Special Standard PUD Zoning District

Project Name: Villages at Sterling Ranch PCD File No.: PUDSP-226

DEVIATION REQUEST (Attach diagrams, figures, and other documentation to clarify request)

PRIVATE ROAD (30' WIDE TRACT)

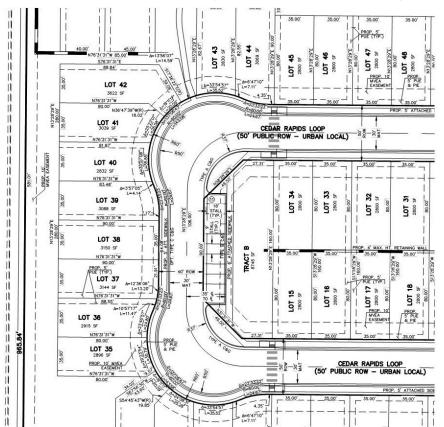
1. ECM 2.2.4.B.7 Special Standards:

Private roads functioning as an alley cannot meet all County public road standards, thus, the following represent the private road standards:

- 30' wide Private Road Tract owned and maintained by Metro. District
- Pavement mat = 22.0'
- Optional Type C C&G each side
- Curb Return radius = 15'
- · Pavement design per County stds.
- Design/Posted Speed = 20 mph
- No sidewalks or parking (Sidewalks provided to front of unit facing open space tract / Offstreet parking stalls provided throughout site)
- Reference City of Colorado Springs Residential Alley Standard for similar criteria (Fig. 20, City of C.S. Traffic Criteria Manual)

Fire Truck Turning Exhibit

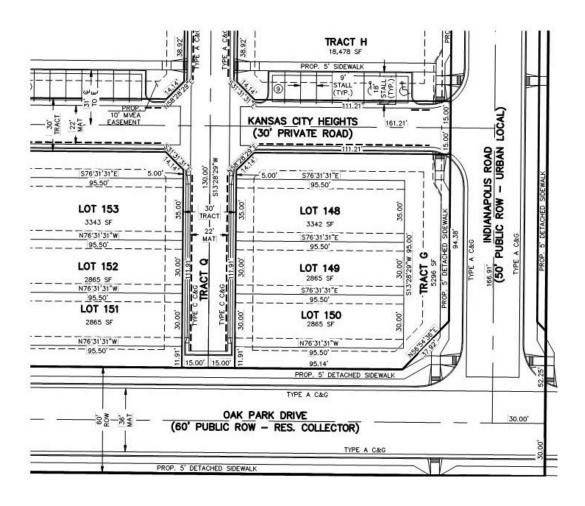
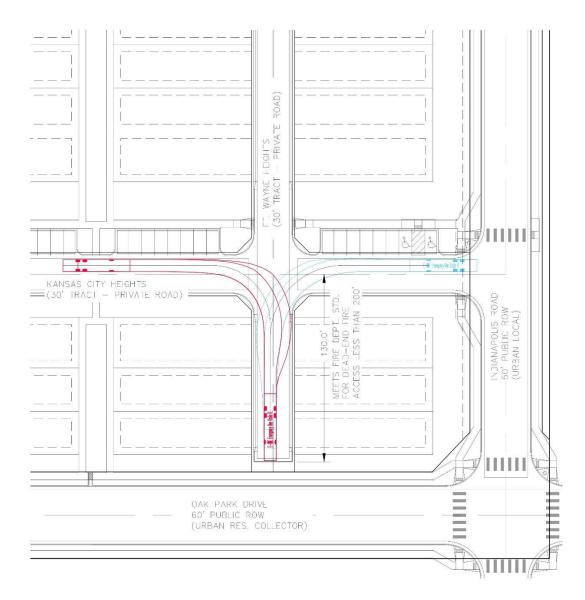
2. ECM 2.3.8.A Special Standards:

Hammerhead turnarounds are not permitted as permanent roadway terminations

This development includes access from private roads that provide turnaround ability for the residents and Fire District but not general public. The following are the design standards for the private roadways with hammerhead turnarounds:

- Max. distance for turnaround = 130'
- Adjacent private driveways provide turnaround ability for residents
- Meets Fire District turnaround standards and lot access with adjacent public ROW
- Curb Return Radius = 15'
- Pavement mat = 22' with opt. Type C C&G each side
- Reference Fire truck turning exhibit below (Meets Fire Dept. std. for dead-end road)

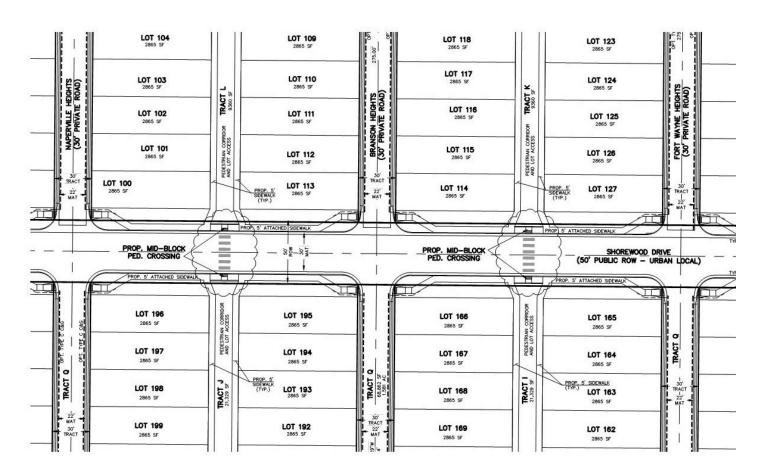
3. ECM 2.5.2.C.2 Special Standards:

Accessible curb ramps - 4-way intersections required ped. Ramps on all four corners

This development includes two 4-way intersections where private streets intersect public streets, however, there are no sidewalks within the private streets as they function more like an alley. Therefore, crossing of the public street at these intersections may not be the best design from a pedestrian standpoint. The following special standards are proposed for these specific intersections:

- The private roads function more as an alley with no sidewalks either side. This rear loaded
 product provides sidewalks at the front of the units within open space tracts. Thus, the need
 for sidewalk crossings at these private street intersections is mainly to cross the private
 roadway and ped ramps are provided for this at each intersection.
- Mid-block pedestrian crossings of the public roadway are proposed to align with the
 pedestrian corridors within the open space tracts that provide sidewalk connection to the front
 of the units.
- The distance between the proposed mid-block ped. ramp crossings of the public road is only 250', similar to the County std. intersection distance.
- Additional signage and striping will be added for these two mid-block crossings.
